Response to CEC Staff Data Request Set No.1 (1-34)

McLaren Backup Generating Facility (17-SPPE-01)

SUBMITTED TO: CALIFORNIA ENERGY COMMISSION

SUBMITTED BY: **Vantage Data Centers**

DR-34 – Campus Site Plan

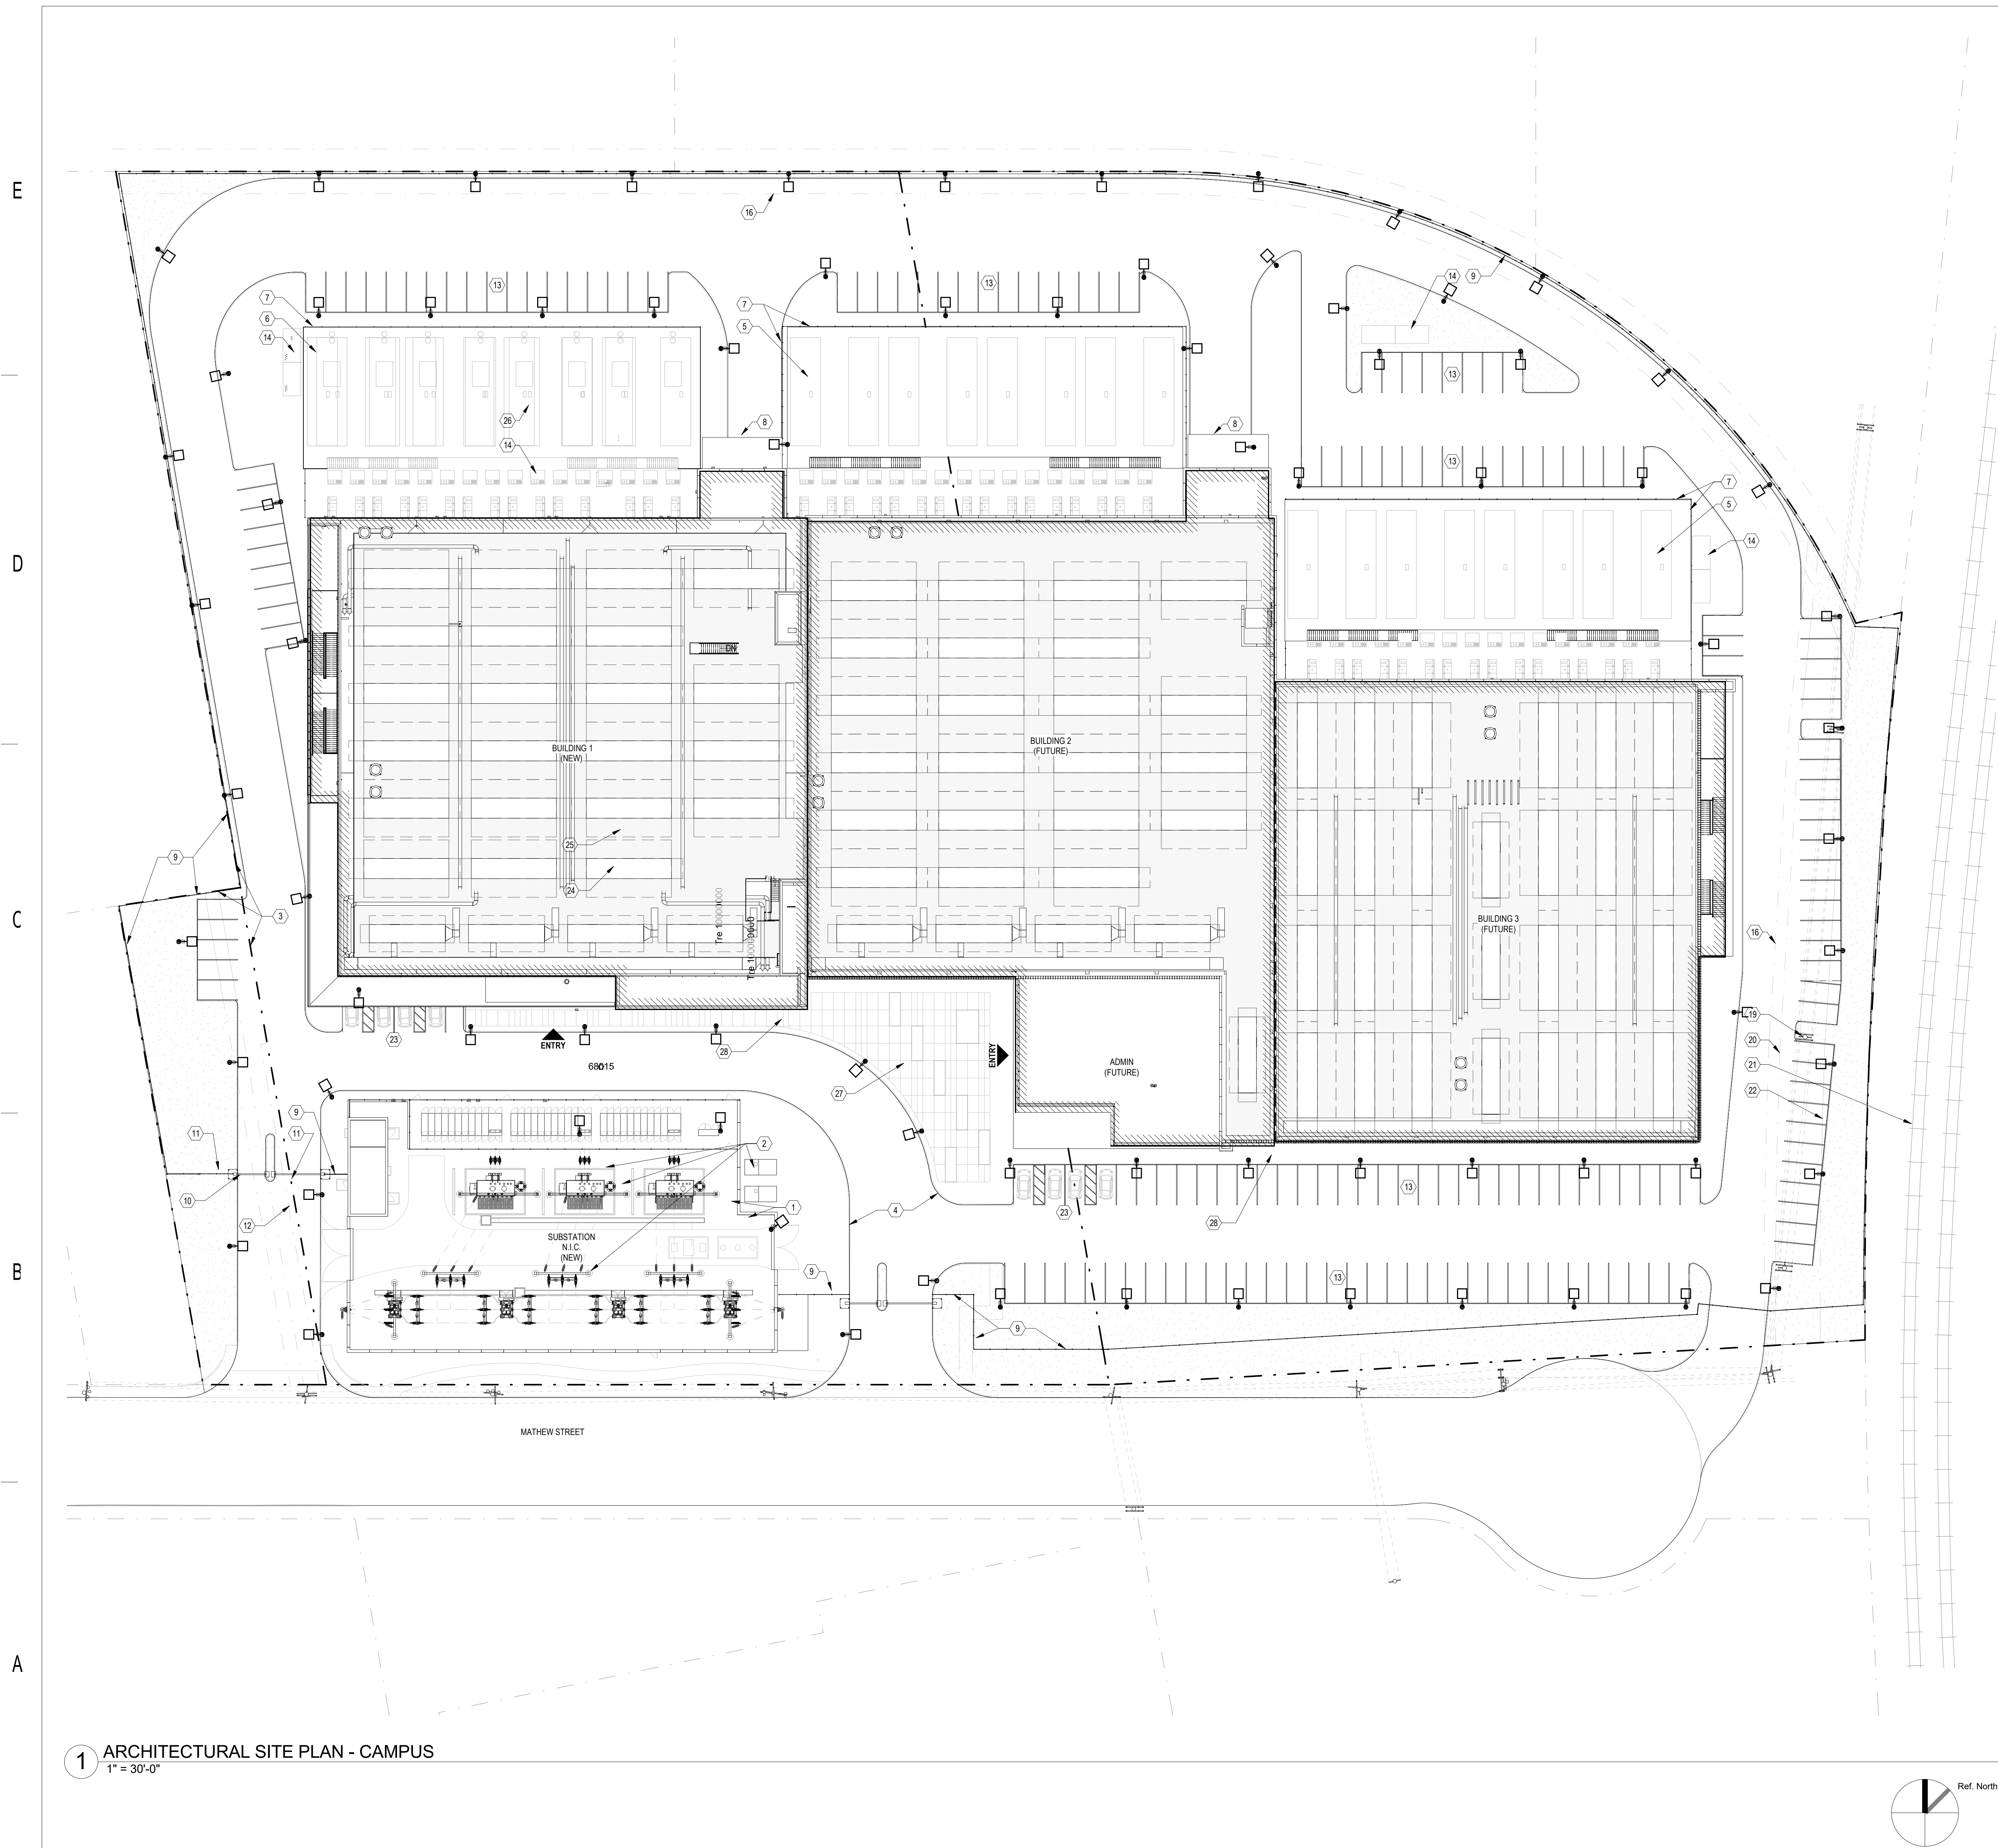
The SPPE application includes Figure 2-1, "General Arrangement and Site Layout," which conceptually shows areas for the data centers and diesel generators. No areas are shown for other project features (e.g., the electrical substation, parking areas, and mechanical equipment yards). Staff anticipates including a description of areas and locations for the main project features in the Land Use and Planning section of the analysis.

34. Please provide an updated figure(s) showing the general arrangement and site layout that includes the main project features, similar to the site plans shown in the city's February 2017 IS/MND. Please label the project features shown on the figure(s).

Notwithstanding the general objection to this data request, please see Attachment DR-34, Figure AS100.02.
